Access Compliance Report

Public Rights-of-Way

(Curb Ramps)

Intersection ID: 10829	Main Street: E_34TH_ST	Cross Street: HOLT_ST	Location: S
ADA ID: AEE738F621C8	Ramp Type: Perp	Initial Pass/Fail: Fail	Overall Compliance: No
Codes/Mitigation Info/Possible Solution		Field Measurements/Component Compliance	
Severity Score: 21.25

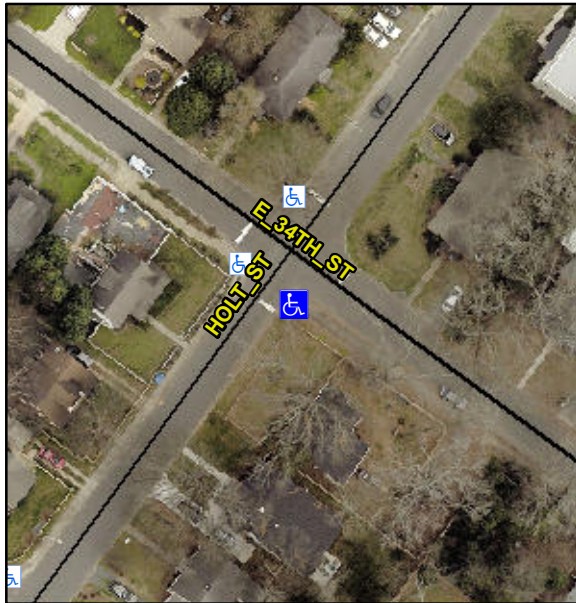
Not Found, R304.5.1, R304.2.2

Compliance	Description	Data	Compliance	Description	Data
N/A	Ramp Length (in)	72.5	No	Ramp Slope (%)	10.5
No	Ramp Width (in)	44.0	Yes	Ramp XSlope (%)	0.9
N/A	Flare Type LT	N/A	N/A	Flare Type RT	N/A
N/A	Flare Slope LT (%)	N/A	N/A	Flare Slope RT (%)	N/A
N/A	Flare Traversable LT?	N/A	N/A	Flare Traversable RT?	N/A
N/A	Landing Length (in)	N/A	N/A	DWS Provided?	N/A
N/A	Landing Width (in)	N/A	N/A	DWS Contrast?	N/A
N/A	Landing Slope (%)	N/A	N/A	DWS Length (in)	N/A
N/A	Landing X Slope (%)	N/A	N/A	DWS Full Width?	N/A
N/A	Landing Curb? (Y/N)	N/A	N/A	DWS Offset (in)	N/A
N/A	Shared Landing?	N/A			
N/A	Gutter Ponding?	N/A	N/A	Gutter Slope (%)	N/A
N/A	Gutter Lip Ht (in)	N/A	N/A	Gutter X Slope (%)	N/A
N/A	Painted X Walk1?	No	N/A	Painted X Walk2?	N/A
	X Walk 1 Direction	To NW		X Walk 2 Direction	N/A
N/A	X Walk 1 Width (in)	N/A	N/A	X Walk 2 Width (in)	N/A
	X Walk 1 Slope (%)	0.2		X Walk 2 Slope (%)	N/A
	X Walk 1 X Slope (%)	2.3		X Walk 2 X Slope (%)	N/A

Remove & Replace Entire Ramp.
